Wollongong Local Planning Panel Assessment Report | 4 December 2019

WLPP No.	Item No. 1
DA No.	DA-2018/1481
Proposal	Mixed Use Residential - residential flat building comprising 21 apartments above basement car parking, 13 townhouses with double garages and tree removals and Subdivision - Strata title - 34 lots
Property	Lot 3 Robert Street, Lot 2 Rothery Street and Lot 1 Wilga Street, Corrimal 2518 Lot 3 DP 1159710, Lot 2 DP 505162 and Lot 1 DP 434080
Applicant	Traders in Purple
Responsible Team	Development Assessment & Certification - City Wide Planning Team (VL)
Lodged	23 November 2018

ASSESSMENT REPORT AND RECOMMENDATION

Figure 1: Inset of ground floor plan at the frontage of the site

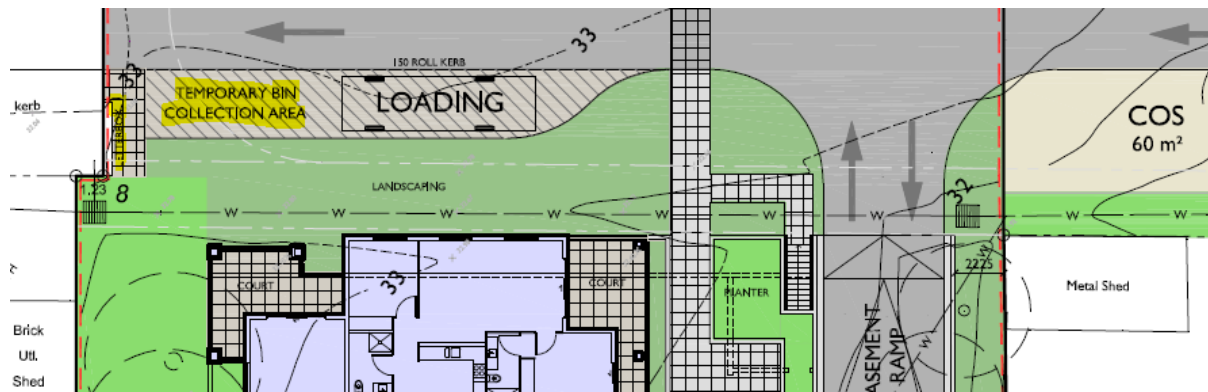
Previously the letterboxes for the RFB were provided adjacent to the site frontage of the property along the southern boundary and the temporary bin collection area adjacent to the north as highlighted in Figure 1 below.

Figure 2: Inset of amended ground floor plan at the frontage of the site

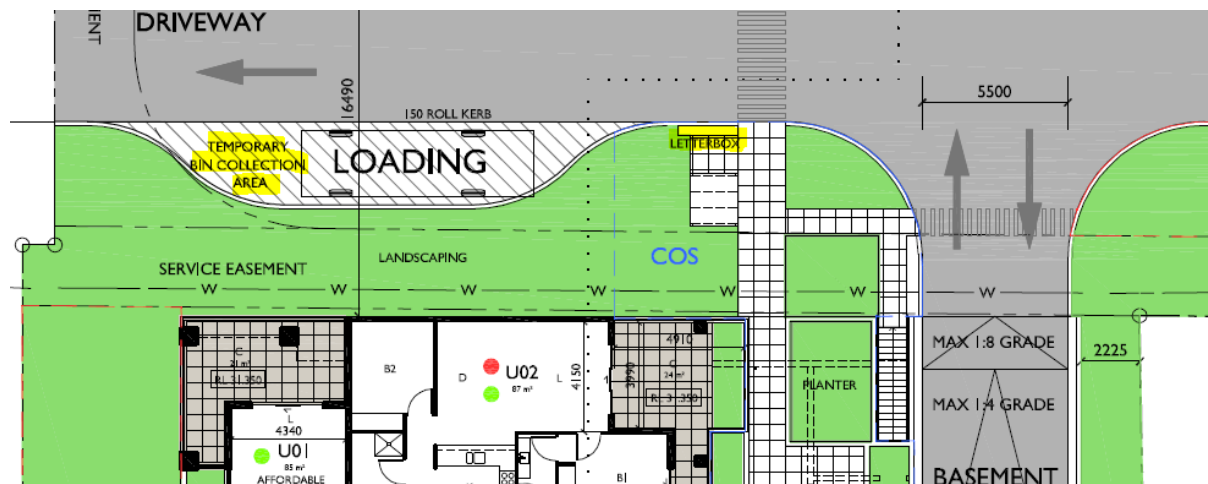
The applicant has relocated the letterboxes further within the site, south of the basement ramp adjacent to the pathway that leads to the RFB entry and the loading bay and temporary bin collection is set slightly back from the frontage of the site buffered by some landscaping as shown as highlighted below in Figure 2.

It is considered that the proposal has satisfactorily addressed this matter as the letterbox (noting now located outside the drainage easement) is situated away from the temporary bin collection and the pedestrian path is not considered to conflict with access and circulation for residents.

Figure 3: Inset of ground floor of RFB highlighted path from street frontage

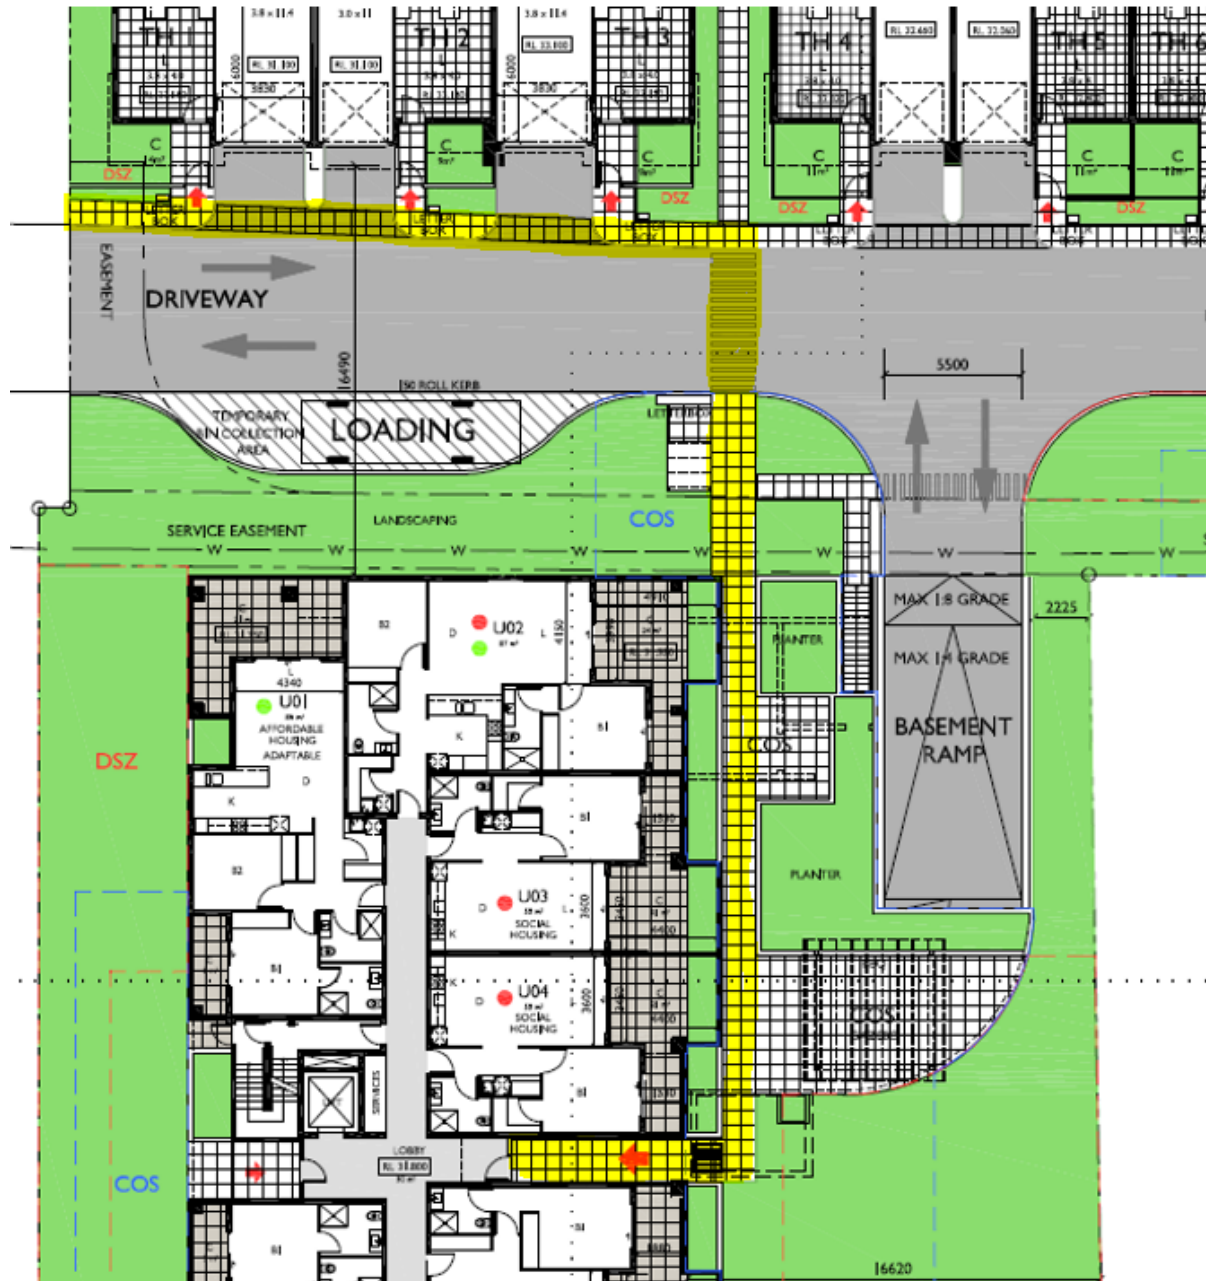
An entry on the western elevation of the RFB has not been provided by the applicant however, this is considered due to the existing drainage easement (and overflow path) that is located adjacent to the western wall of the building. Any openings on this elevation would allow stormwater to enter the

building unless the entrance was raised above natural ground level. The main entrance to the RFB is located towards the centre of the northern side of the building and considered to be clearly defined from Robert and Wilga Street. Also, the proposed pedestrian path is accessible to the entry point of the building and does no conflict with the proposed loading area. The building entry is clearly visible from the internal driveway and COS that the path adjoins. Refer to Figure 3 that highlights the path from Robert Street to the building entry. Overall, it is considered the current primary entry to the building is acceptable given the design and site constraints.

Figure 6: Inset RFB ground floor plan of U06

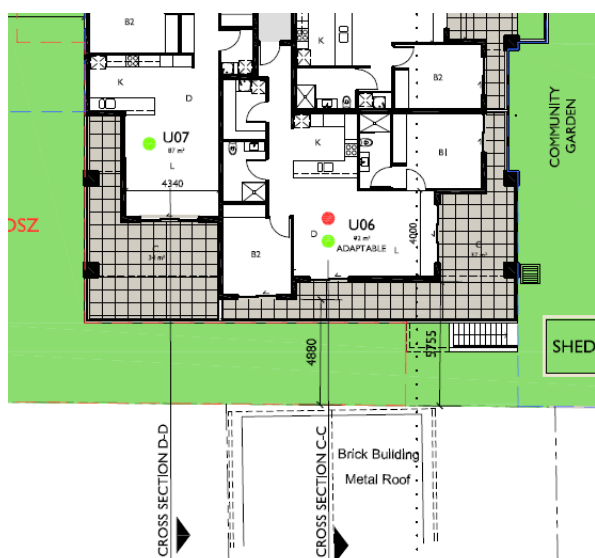
On the ground floor U06, a 4.88m setback is provided to a bedroom window and 5.755m to the living room window. Refer to Figure 6.

As shown the plans in Figure 6 and 7, the bedroom and living room look towards the rear of 12 Cross Street and directly towards the existing outbuilding and partially towards the rear of 14 Cross St. The windows are surrounded by a courtyard for U06 that is setback approximately 3.8m from the eastern boundary. This courtyard will contain a privacy screen to provide an overall height of 1.8m. Planting with a minimum width of 1.5m is proposed is along the entire length of the eastern boundary that will provide additional buffer/screening between the unit and adjoining property. Due the nature of the use of the windows as a bedroom and secondary living room window with the associated screening and predominant line of sight the outbuilding on the adjoining property, it is considered the potential for overlooking is minimised and there would be no adverse amenity impacts on the adjoining properties.

Figure 7: Part section of RFB of U06 and 12 Cross Street

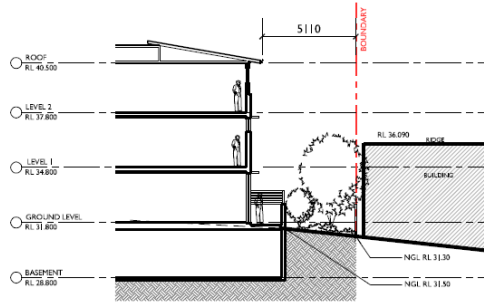
Cross sections have been provided at **Attachment 1**, on the Ground Floor Plan shown as Part Section C-C below with the adjoining property 12 Cross Street that has an outbuilding located along their rear boundary as shown in Figure 7. This outbuilding does not contain any window openings on the western elevation.

**Figure 8: Inset of first floor plan of U13**

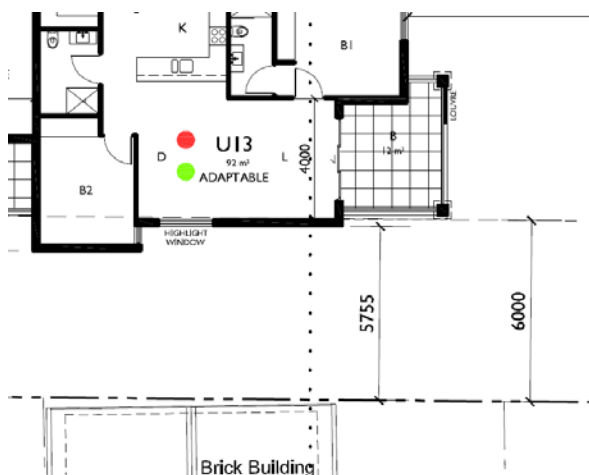
The living room windows for U13 (L1) and U20 (L2) are setback 5.755m. Refer to Figure 8 and 9.

These living room windows on the eastern elevation are proposed with a high sill window and as such is not expected to result in unreasonable impacts on visual privacy on the adjoining properties to the east. Refer to Figure 10 that shows the proposed windows for these 2 units.

Figure 13: Extract from Height Plane Diagram indicating portions of the roof of the proposed residential flat building that exceeds 9m building height, shown in grey (ADM Architects Drawing No. A-405)

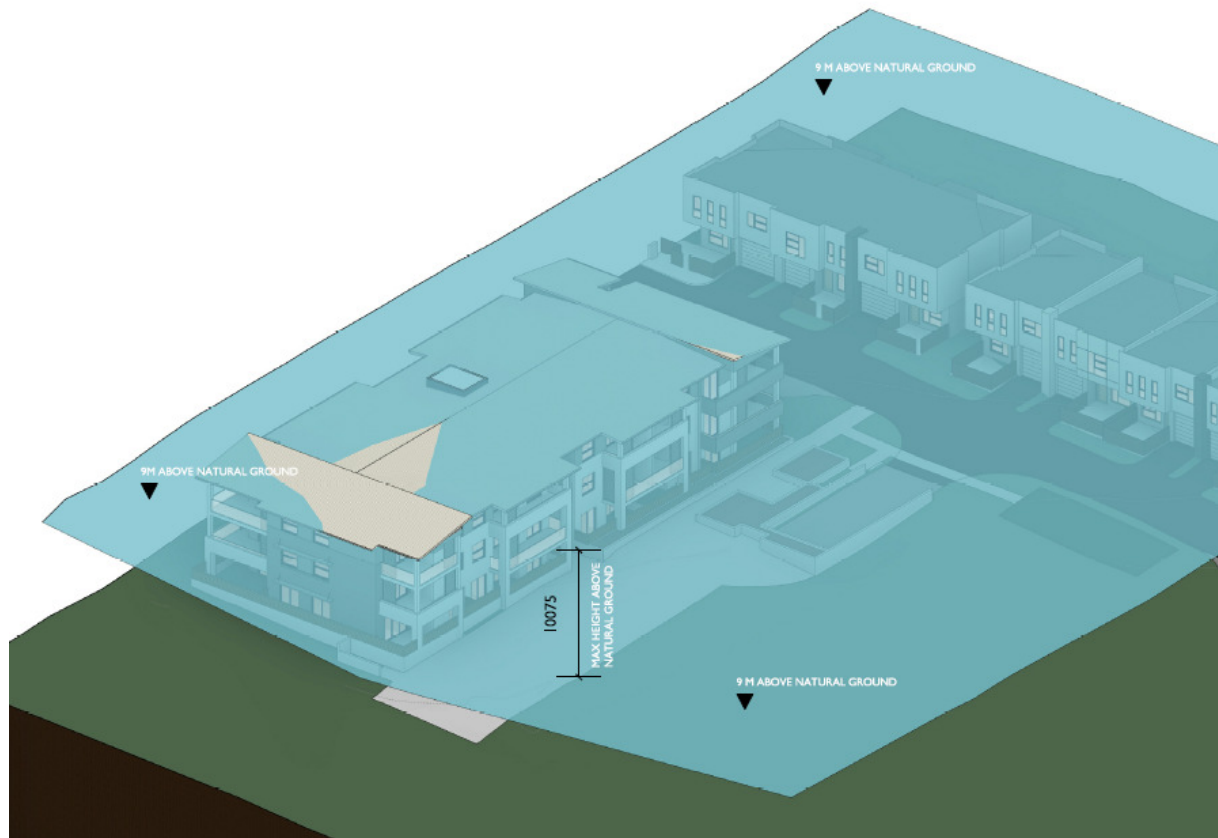
Figure 10 below is an excerpt from the Height Plane Diagram prepared by ADM Architects which illustrates the portions of the residential flat building that exceed the 9m building height, in grey). The variation predominantly relates to the roofing materials of two portions of the building that exceed 9 metres up to a maximum building height of 10.075 metres (measured from natural ground level to ridge level). The remainder of the building (being the vast majority of the structure) has a building height less than 9 metres.

It is noted that the revised design (June 2019) has resulted in a lesser level of encroachment into the building height plane, when compared to the previously submitted design.
